**Optimization Review**  
**Jones Road Superfund Site**  
**Harris County, Texas**

Report of the Optimization Review

August 01, 2014

Revised 20 August 2014

GSI Job No. <b>G-3830</b>	Drawn By: <b>DLB</b>	<b>DISTRIBUTION OF PCE IN SHALLOW SOIL</b> Jones Road NPL Site Harris County, Texas
	Issued: <b>13-Aug-13</b>	Chk'd By: <b>MV</b>	
	Revised: _____	Apr'd By: _____	
	Scale: <b>As Shown</b>	<b>FIGURE 3</b>

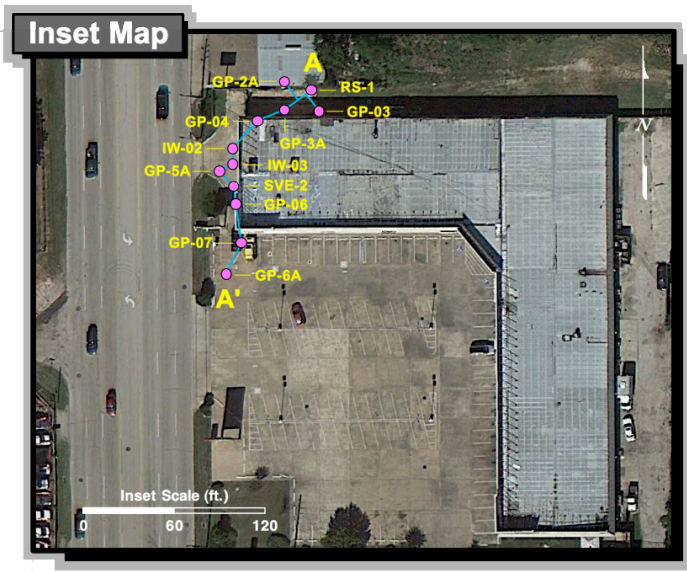
SVE is recommended for the shallow clay soil in the area immediately behind and beneath the shopping center, focusing on the area around the SVE-01. Although the Shallow Soil has fairly low permeability, SVE may be a viable remedy in the limited area of highest contaminant mass (see Figure 3). Based on the continued use of the shopping center and the limited access to the area of high contamination (in an alley behind the shopping center and below the building), excavation or thermal treatment are not practical. SVE may not fully remediate contamination in this zone, but would serve to address an area of highest residual contaminant mass and, therefore, limit migration to the Shallow WBZ, indoor air and deeper strata.
